Reply to Referee #2's comments

Title: A flux tower site attribute dataset intended for land surface modeling

No.: essd-2024-77

Revised (Figure 2):

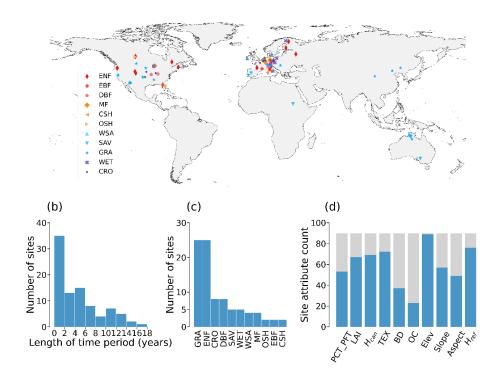
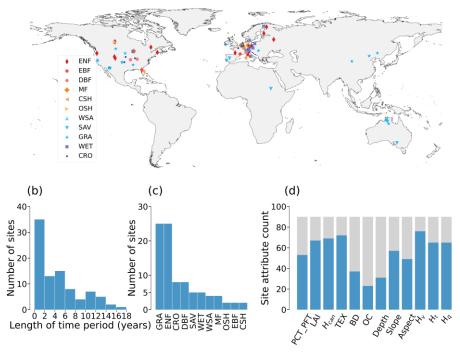
Comment 2: Regarding the soil attributes that were included for the sites, I'd be interested why the authors do not mention soil depth. I'm aware that soil depths measurements are generally not available for the sites, but it is an important variable in many LSMs. Even if it is obtained from global gridded datasets, it could still be useful to include in this dataset. Another variable, which was not included, is the measurement height of air temperature. As this is required in several LSMs and is not always the same height as the measurement height of wind speed, I think it would be useful to include the air temperature measurement height as well or explain why it was not included.

Comment 7 (L76): Why are LAI and canopy height included in the four most important attributes, even though they aren't required as inputs for many LSMs? Soil depth, however, is not mentioned, which can strongly impact model outputs and is required my many LSMs as well.

Comment 23 (Figure 2): Don't you mean "number of years", not "site numbers" in the caption for (b)? In (d), is this the actual number of sites or the percentage? The name Hcan is a little confusing, as you talk about sensible heat flux as H above and here H is height.

Thanks for the reminder. Soil depth is indeed an indispensable variable in LSMs. Therefore, we have added the site soil depth data to the attribute dataset. The dataset is available at https://doi.org/10.5281/zenodo.12596218. We have also updated the graphs and related text describing the attribute data.

Revised (Figur 2 caption):

"(d) Number of collected site-observed attribute data for PCT_PFT, maximum LAI (LAI), mean canopy height (H_{can}), soil texture (TEX), bulk density (BD), organic carbon concentration (OC), and soil depth (Depth), slope, aspect, and reference measurement height (Wind: H_v ; Air temperature: H_t ; Humidity: H_q)."

Response 23: Thanks for your suggestion. In Figure 2 (b), the vertical coordinate is the number of sites, and the horizontal coordinate is the number/length of years.

H (sensible heat) and canopy height (H_{can}) do tend to be confusing, so we plan to change the abbreviations for sensible heat and latent heat to Qh and Qle in the manuscript submission after discussions, and the abbreviation for canopy height will remain the same. Thank you very much for your suggestion.

Revised (Figure 4):

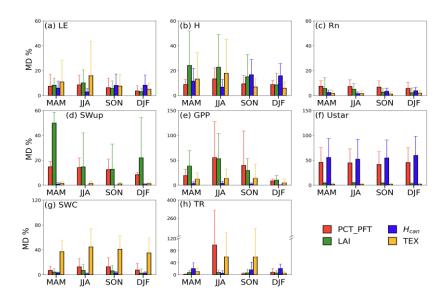
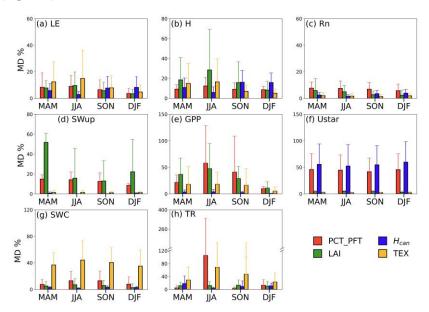
Comment 19 (L224): Why only the first year and not all available years at the sites? One year could be

an unusual/extreme year and not representative of the usual site conditions.

Response 19: Thank you for your suggestion. It's true that using only one year of data for SPIN-UP is not quite right. Therefore, we have changed the SPIN-UP approach. The new scheme loops the atmospheric forcing data for each site's observation period until it reaches 50 years.

We redrew the pictures associated with the model results (including Figure 4, Figure 5, Figure 6, and Figure 7). Overall, these figures don't change much. And the relevant MD% values in this paper are modified. The comparison before and after modification is as follows:

Revised (Figure 7):

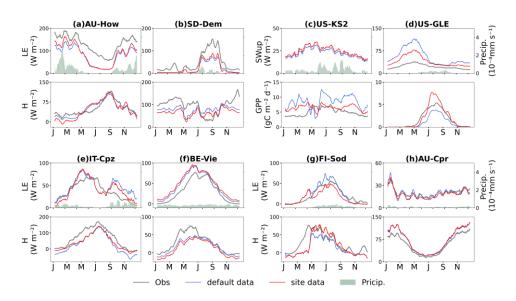
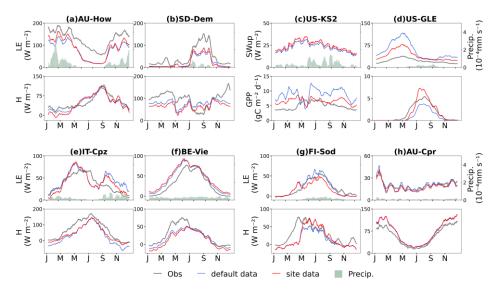
Comment 3: Some of the Tables and Figures could be improved by organizing sites in the same order for the different variables that are shown or to show the selected variables for all the sites. For example, Table 2 and Figure 7 could be made clearer.

Comment 31 (Figure 7): Why do you show SWup and GPP at 2 sites only and don't show the LE and H there? Also, it doesn't seem to show observations for SWup at US-KS2. Why show that variable at that site, if observations were not available? Why were these specific 8 sites chosen for the figure (and not all 36 sites) and why don't you show LE, H, GPP and SWup at all the selected sites?

Figure 7 is intended to illustrate that the impact of attributes is substantially associated with precipitation. We intentionally chose two typical sites for each attribute and formed a contrasting effect to illustrate the important role of precipitation. Therefore, only 8 sites are ultimately shown. We have added this information to the description of Figure 7. Please refer to Response 31 for specific details.

Response 31: Thank you for your question. I'm sorry for the confusion. In the modeling assessment of attribute data, four attributes were selected, and Figure 7 shows two typical sites for each attribute (which can be contrasted to highlight the important role of precipitation). We have added this information to the description of Figure 7.

The US-KS2 and US-GLE sites are used to illustrate the role of precipitation in the impact of LAI on model results. Specifically, the result of SWup is more convincing, so we have co-displayed SWup at the US-KS2 and US-GLE sites. Although the US-KS2 site does not have SWup observations, we can still see the difference in the simulations between the site data and the default data.

Figure 7 is intended to illustrate that the impact of attributes is substantially associated with precipitation. We intentionally chose two typical sites for each attribute and formed a contrasting effect to illustrate the important role of precipitation. Therefore, only 8 sites are ultimately shown.

Revised (Figure 7 caption):

"and GPP at 8 selected sites (two sites for each attribute for comparison. PCT_PFT: AU-How and SD-Dem; LAI: US-KS2 and US-GLE; H_{can} : IT-Cpz and BE-Vie; Soil texture: FI-Sod and AU-Cpr)"
